Effective Date: Nov. 23, 2018

Matrix T-5x/7xe-03/04-F / T-130X
(TM501E/TM501F/TM501G/TM501I/TM501J/
TM501K/TM501L/TM501M/TM501Q/TM501R/TM501V)/TM539

Bulletin Num.
NB-1811005

SYMPTOM

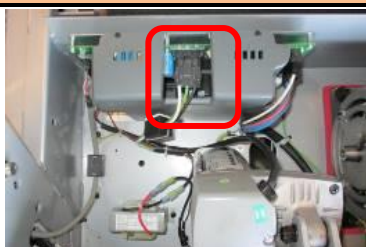
Please be aware that the MX-T5x/T7xe and T-130X frame will now use the T1x/T3x MCB*.

The current MCB is short of some ICs (ex.IGBT) components. It's happened globally and the manufacturer will not continue to provide these components.

Table -1. The chart below shows the differences between the old and new MCBs

*Find troubleshooting information for the new MCB in the document "New AC MCB". This resource is posted under Service Guides.
